Traffic Engineering Response to Council Information Request

To	Courtney Upper Coomera Developments Pty Ltd	Date	28 August 2026
Prepared by	Kevin Liu, Modus Traffic Engineer	Approved by	Harj Singh, Modus Executive Director (RPEQ 22364)
Location	17 Courtney Drive, Upper Coomera		
Subject	Proposed Residential Subdivision Development - Traffic Engineering Response		
Status	Final	Attachments	Appendix A: Council Information Request Appendix B: Revised Development Plans Appendix C: Swept Path Assessment

Information Request Item 8

Revised Development Plans

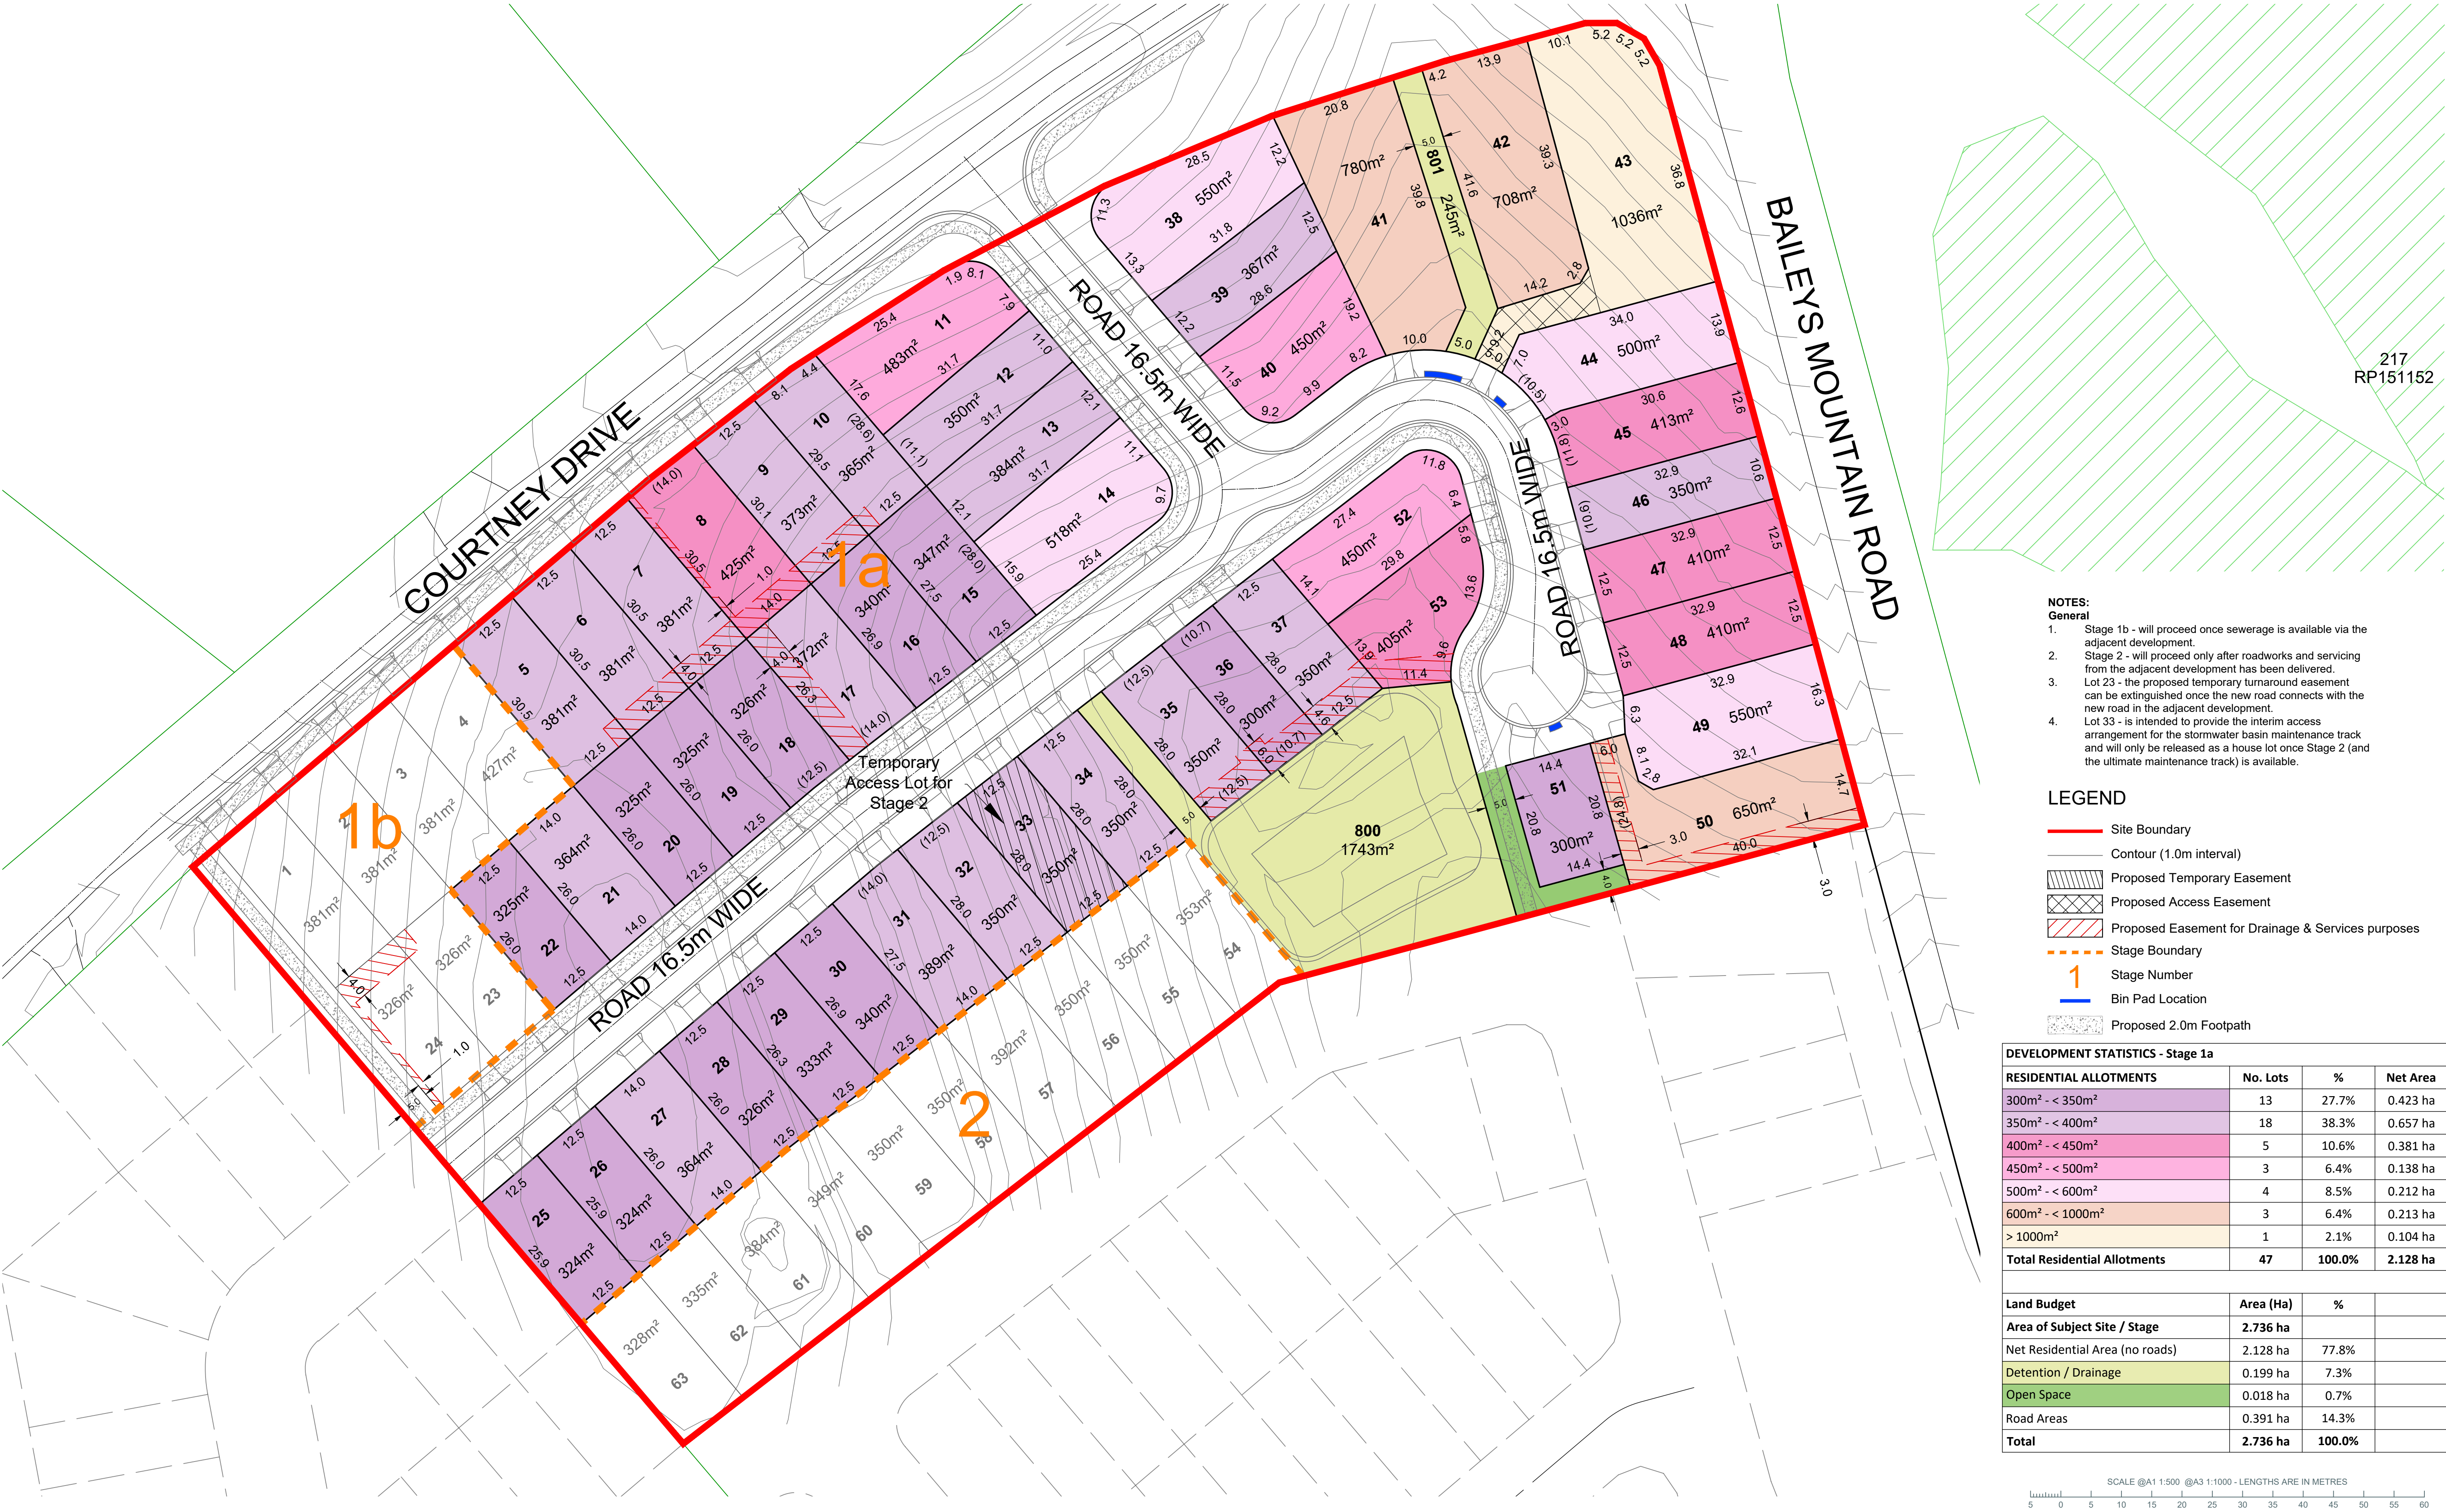
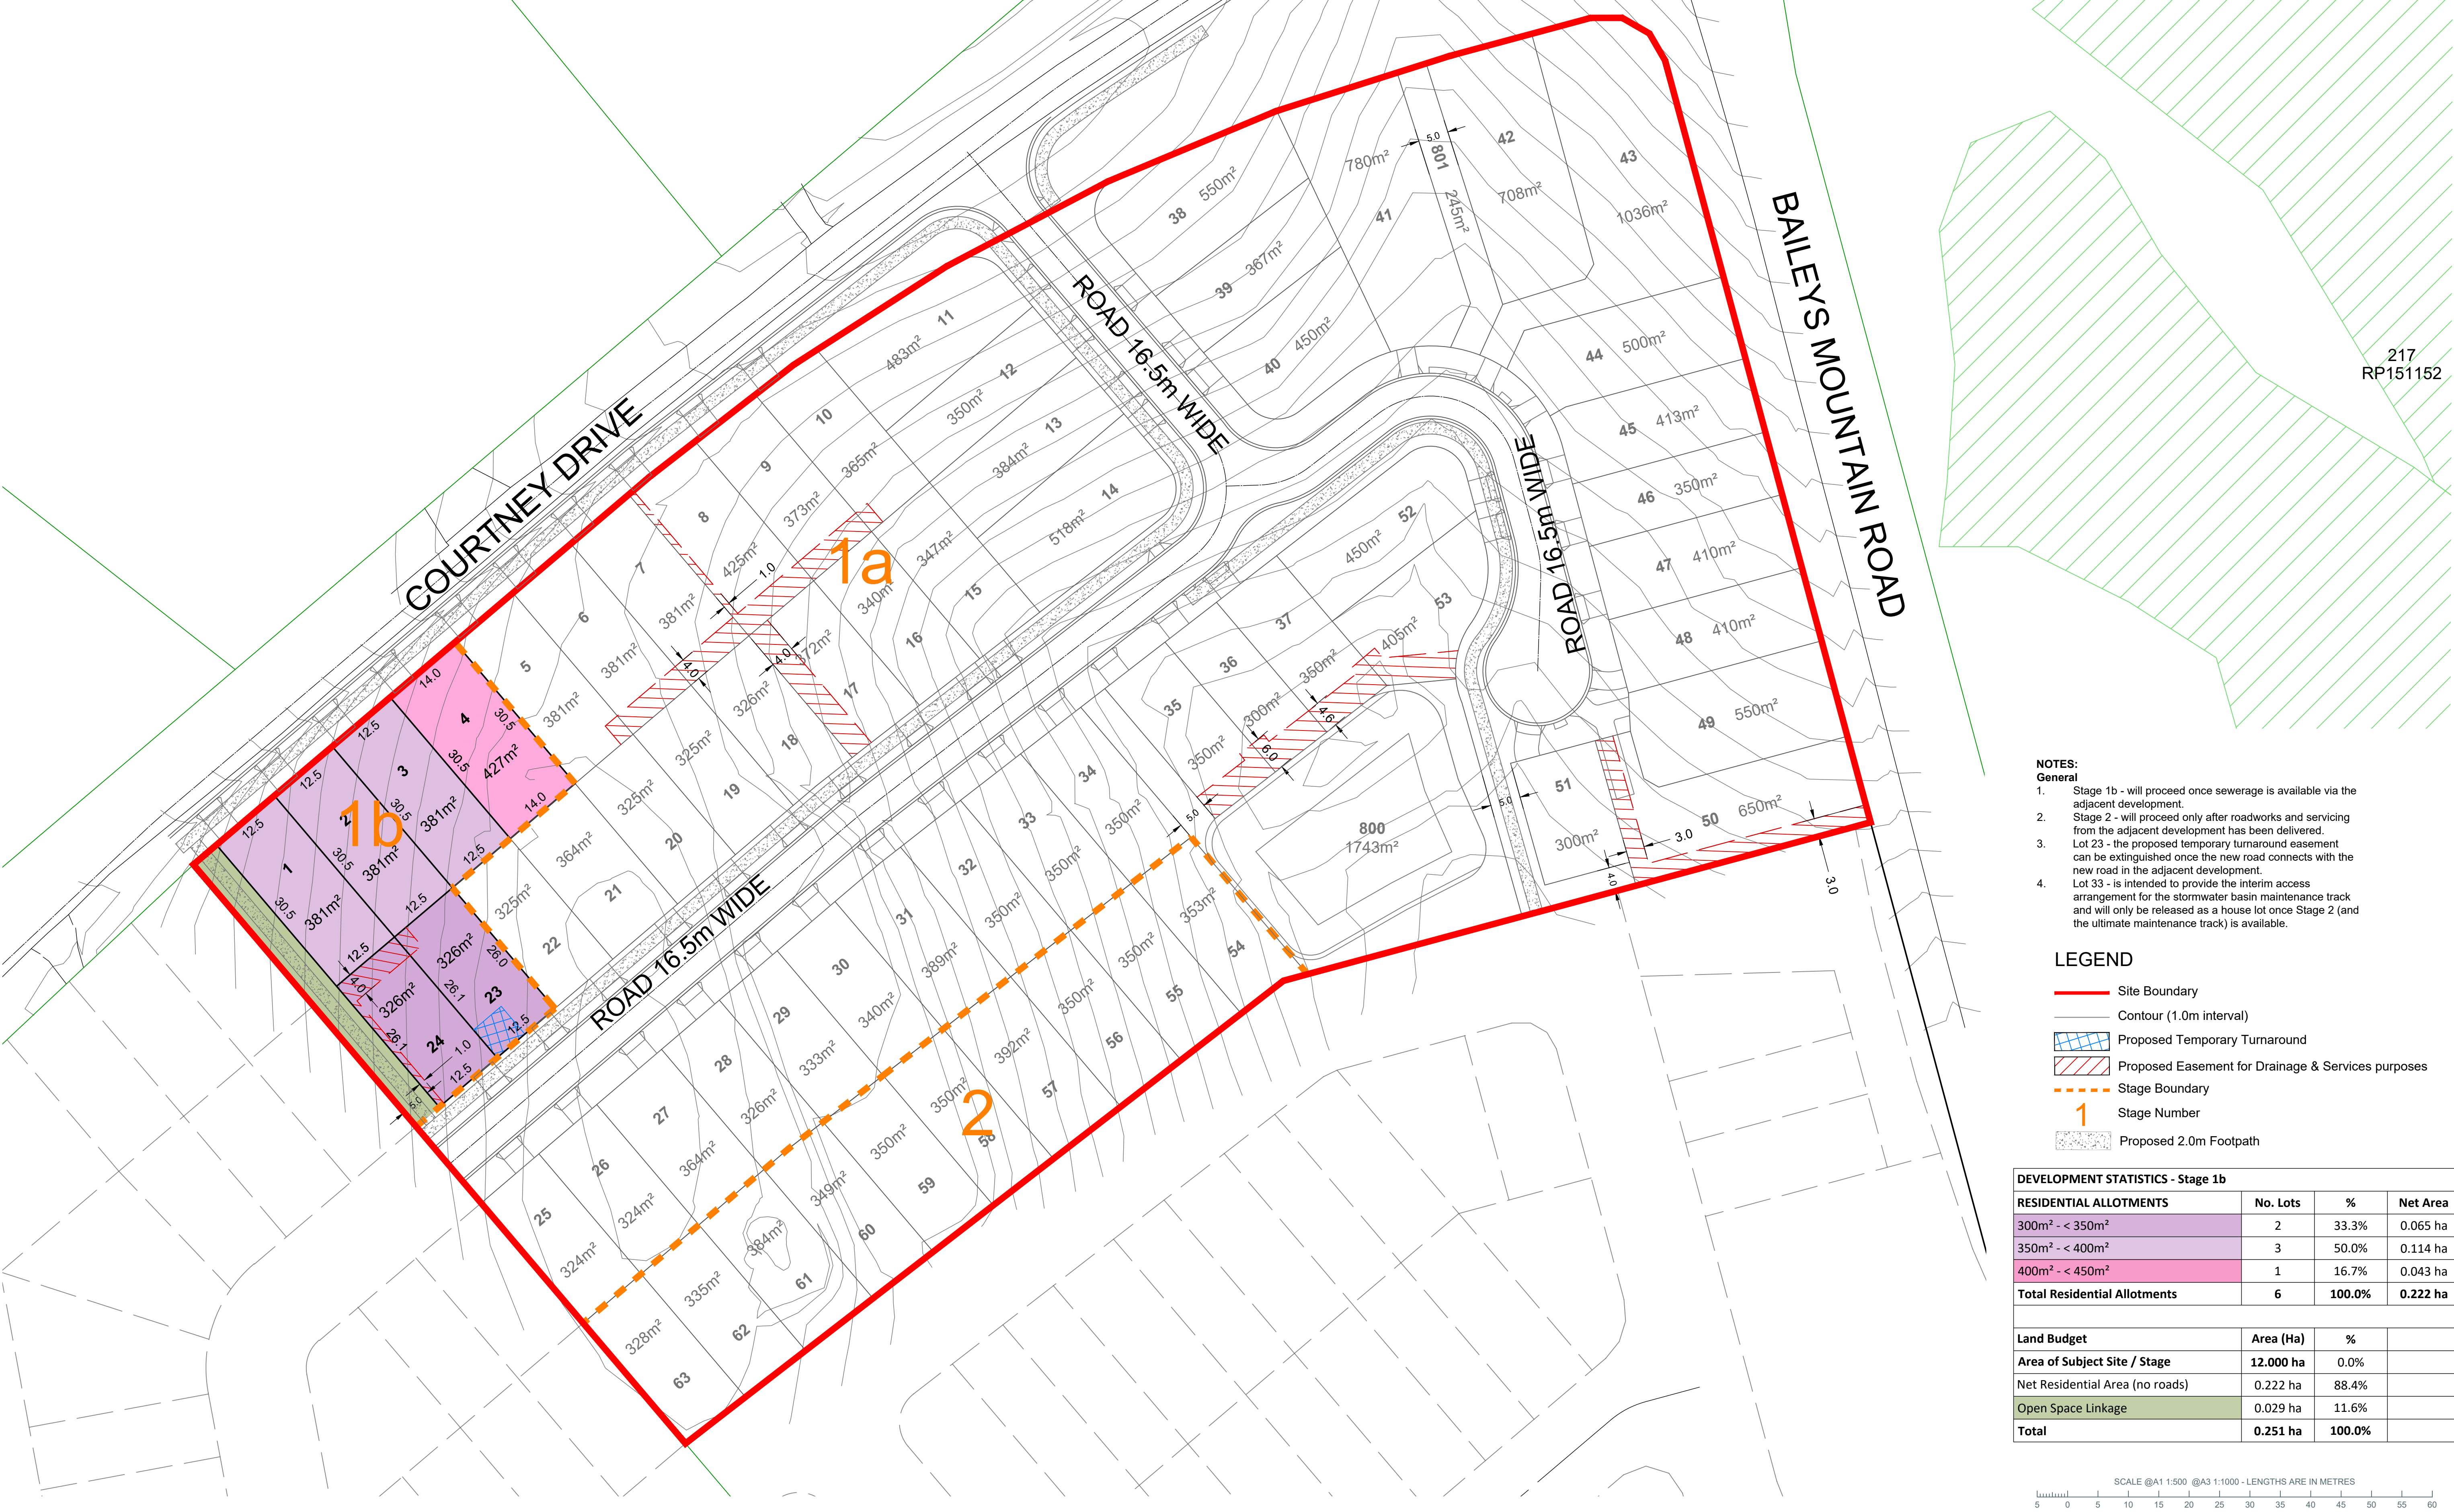
- d) Provide an updated ROL plan, demonstrating the size and location of bin pads for proposed lots with narrow or constrained frontages (i.e. Lots 41, 42, 43, & 44, or where the Road 01 temporary dead-end exists) to ensure a side-loading refuse collection vehicle can adequately service each proposed lot within the development site.*

The revised ROL plan identifies nominated bin presentation areas for Lots 41, 42, 43 and 44, together with the relevant constrained frontage areas associated with the temporary Road 01 arrangement.

The nominated presentation areas have been positioned adjoining the public road frontage so that bins can be presented for collection from the subject lot frontage while maintaining access for the side-loading RCV.
